## WORK ORDER NON-CONFORMANCE / UPDATE

Work Order: <u>93997</u> Part No. <u>D212-664-101TRN</u> NCR No. <u>12-2155</u>				<b>DISPOSITION</b> Rework <input type="checkbox"/> Scrap <input type="checkbox"/> Use-as-is <input checked="" type="checkbox"/> Work Order Update <input type="checkbox"/>		<b>AGAINST DEPARTMENT/PROCESS</b>

<b>DART AEROSPACE LTD</b>	<b>Work Order:</b>	<b>93997</b>
<b>Description:</b> Crosstube Assembly (205/212/412 High Fwd)	<b>Part Number:</b>	<b>D212-664-141</b>
<b>Inspection Dwg:</b> D212-664-141 <b>Rev:</b> D		<b>Page 1 of 2</b>

DRAWING NO. D212-664-141	TITLE XTUBE ASSY (205/212/412 HI FWD)	REV. D	DART AEROSPACE LTD ENGINEERING ORDER		D.E.O. NO. D212-664-141-D-1	SHEET NO. SHEET 1 OF 2	SCALE NTS
DRAWN	CHECKED	MFG. APPR.	APPROVED	DE APPR.			
DATE 11.04.07	DATE 11.07.11	DATE 11.04.12	DATE 11/04/12	DATE 11.04.12

**D212-664-141/-141B**  
**ASSEMBLY DETAIL**

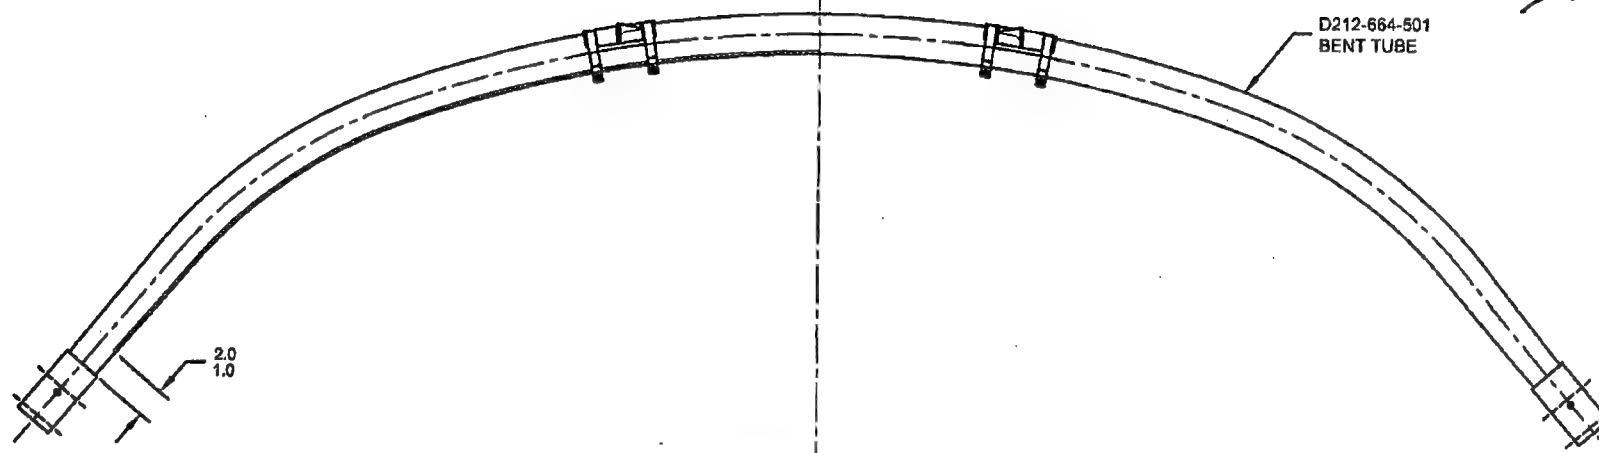
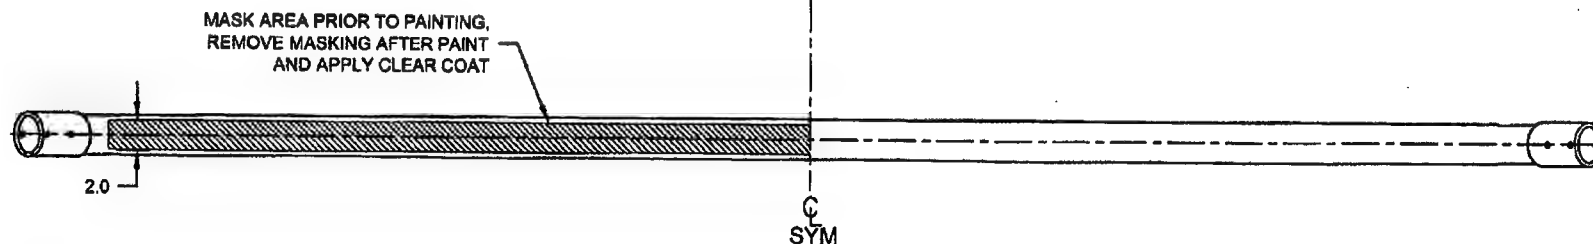
**PURPOSE:**

ADD AN INSPECTION WINDOW TO UNDERSIDE OF CROSSTUBE.

NOTES 2 OF SHEET 1 IS AMENDED AS FOLLOWS:

- 2) FINISH: CHEMICAL CONVERSION COAT PER DART QSI 005 4.1  
PRIME INSIDE AND OUTSIDE PER DART QSI 005 4.2  
MASK UNDERSIDE OF CROSSTUBE AS SHOWN (HATCHED AREA) AND  
PAINT OUTSIDE PER DART QSI 005 4.2  
REMOVE MASKING AND APPLY CLEAR COAT

- 2) FINISH: CHEMICAL CONVERSION COAT PER DART QSI 005 4.1  
PRIME INSIDE AND OUTSIDE PER DART QSI 005 4.2  
PAINT OUTSIDE PER DART QSI 005 4.2

NOTE 12 & 15, SHEET 1 IS AMENDED AS FOLLOWS:

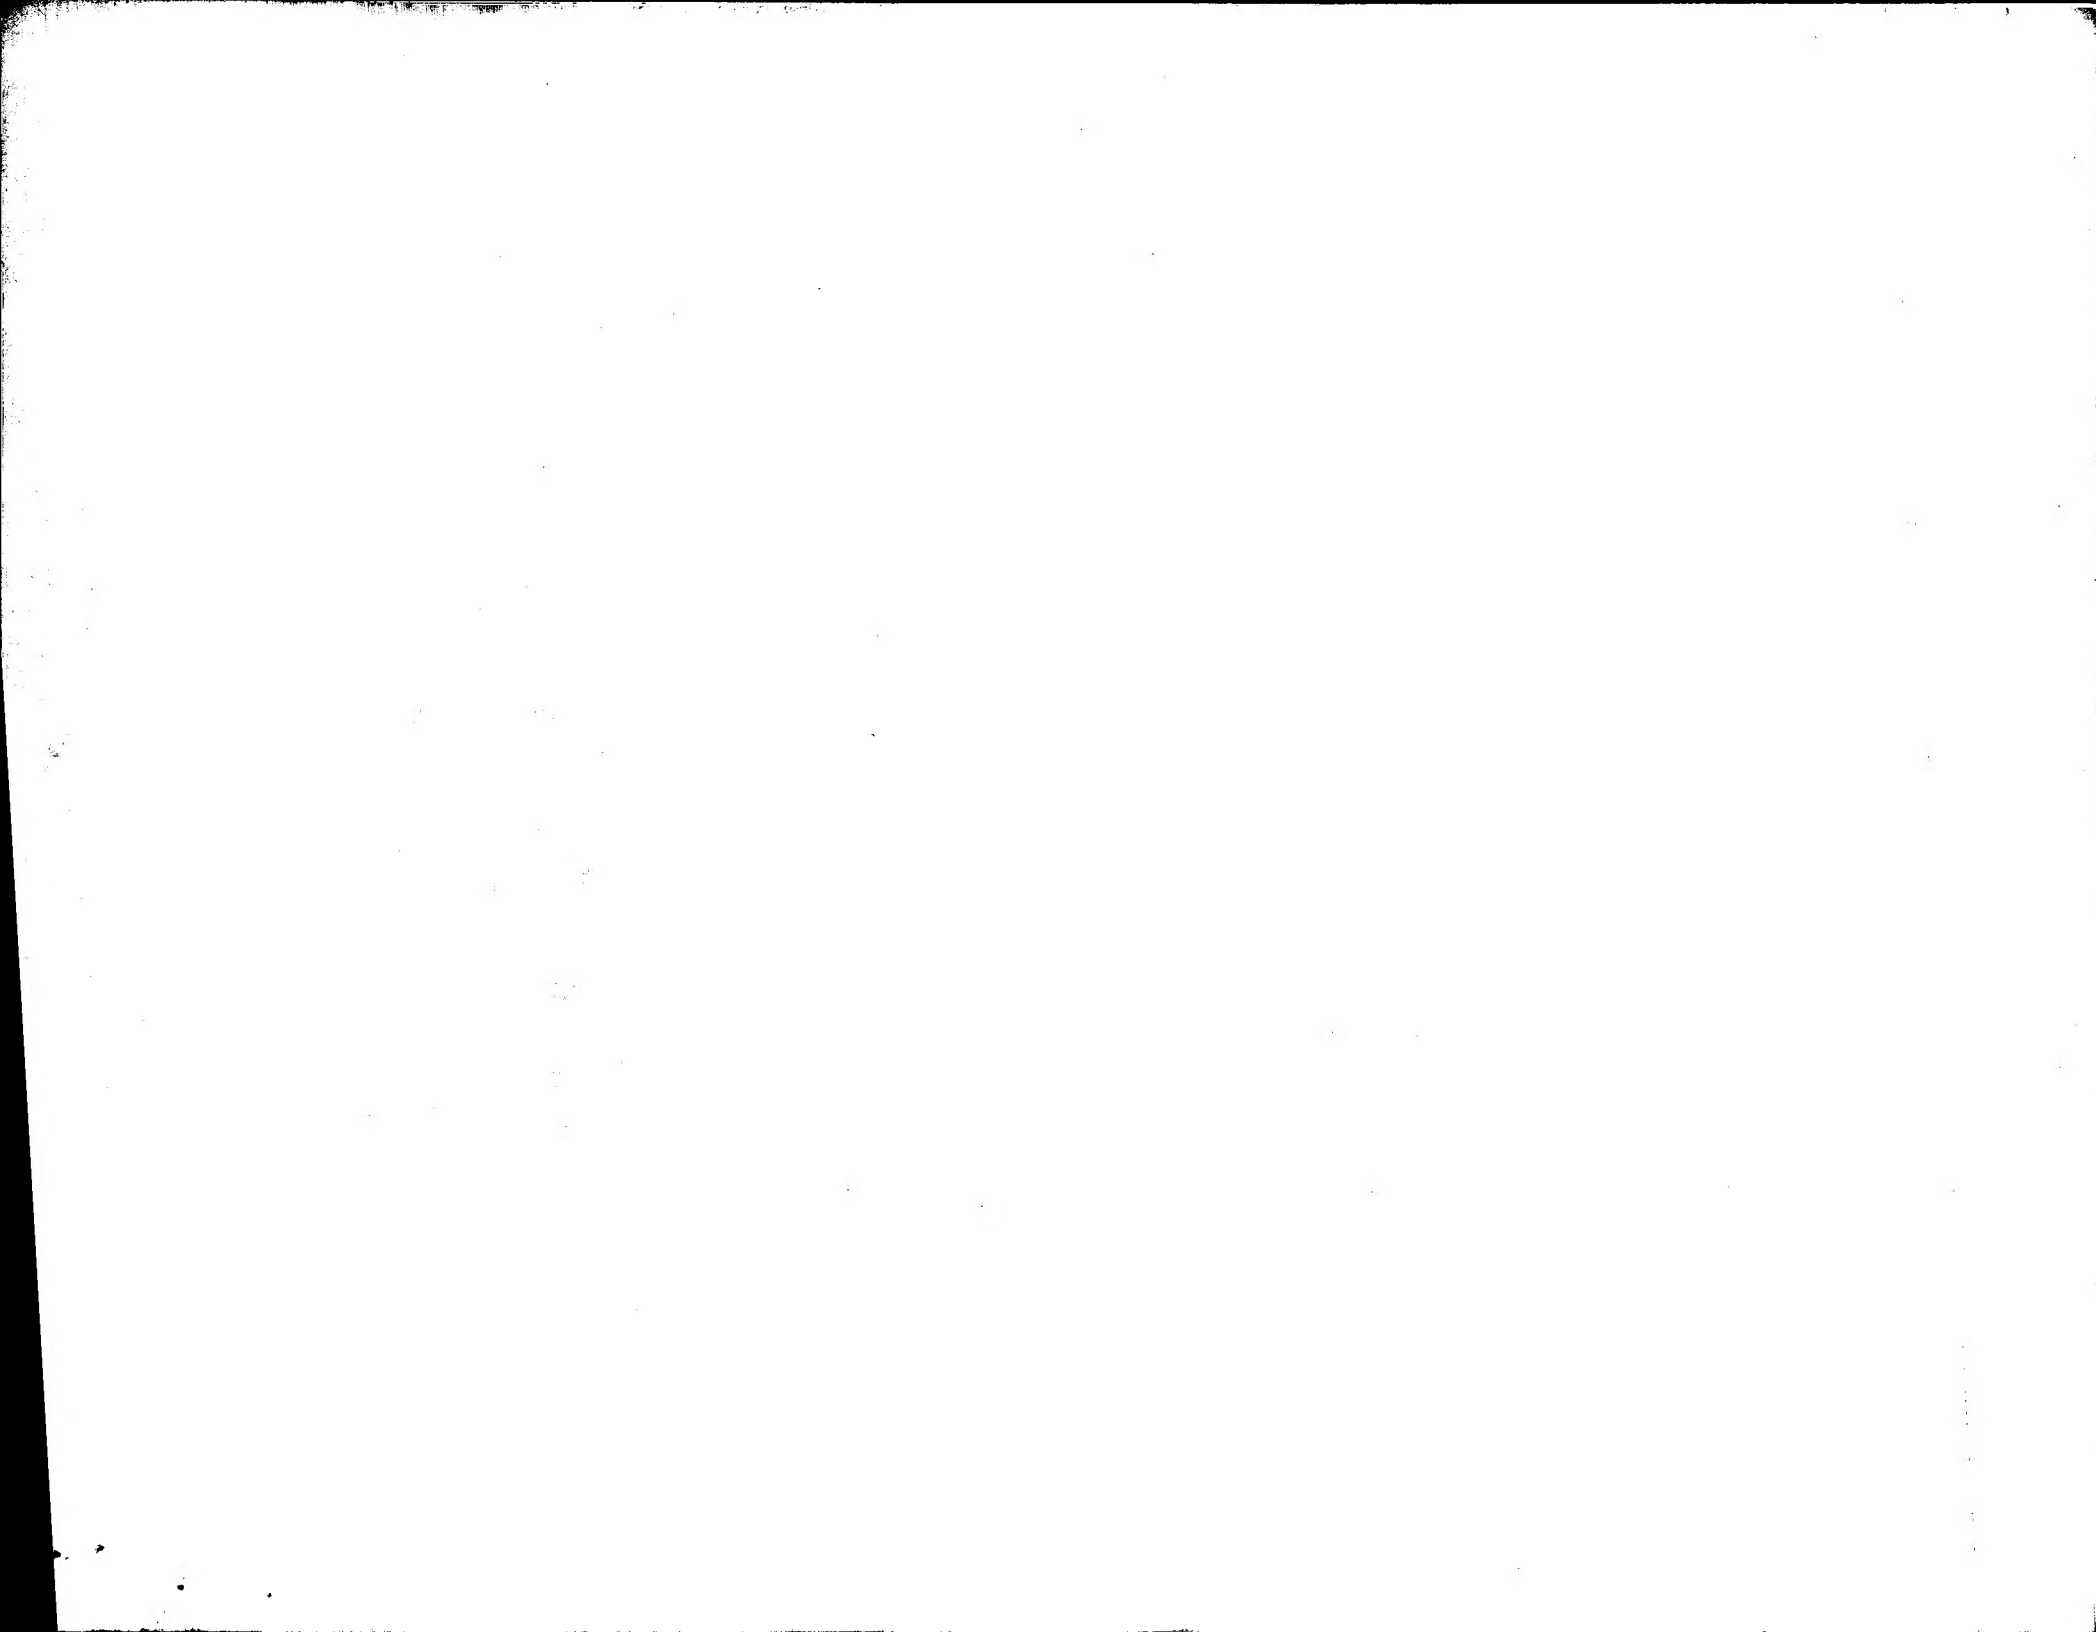
**PURPOSE:**

REPLACE MAGNOBOND WITH PROSEAL.

- 12) TO INSTALL D2893-1 SUPPORT: ABRASE MATING SURFACE OF SUPPORT AND CROSSTUBE WITH 180-GRIT SANDPAPER AND REMOVE RESIDUE WITH MEK (OR EQUIVALENT). APPLY A 0.04" TO 0.07" THICK LAYER OF PROSEAL 890 CLASS B-2 (OR AMS-S-8802 CLASS B-2) SEALANT TO MATING SURFACE OF SUPPORT.
- 15) TORQUE CLAMPS 80 TO 100 IN-LB. ENSURE AT LEAST 1.5 THREADS SHOWING IN SAFETY AND THAT NUT HAS NOT BOTTOMED-OUT AFTER TORQUING. **PRIOR TO PACKAGING, RE-CHECK TORQUE ON CLAMPS AFTER PROSEAL 890 SEALANT HAS CURED FOR 72 HOURS.**

- 12) INSTALL D2893-1 SUPPORT USING 0.03" TO 0.06" THICK LAYER OF MAGNOBOND 6398 TO THE SURFACE OF D2893-1 THAT WILL BE IN CONTACT WITH THE CROSSTUBE PER QSI 015. LET CURE FOR 12 HOURS AFTER INSTALLATION AND PRIOR TO PACKAGING.
- 15) TORQUE CLAMPS 80 TO 100 IN-LB. ENSURE AT LEAST 1.5 THREADS SHOWING IN SAFETY AND THAT NUT HAS NOT BOTTOMED-OUT AFTER TORQUING.
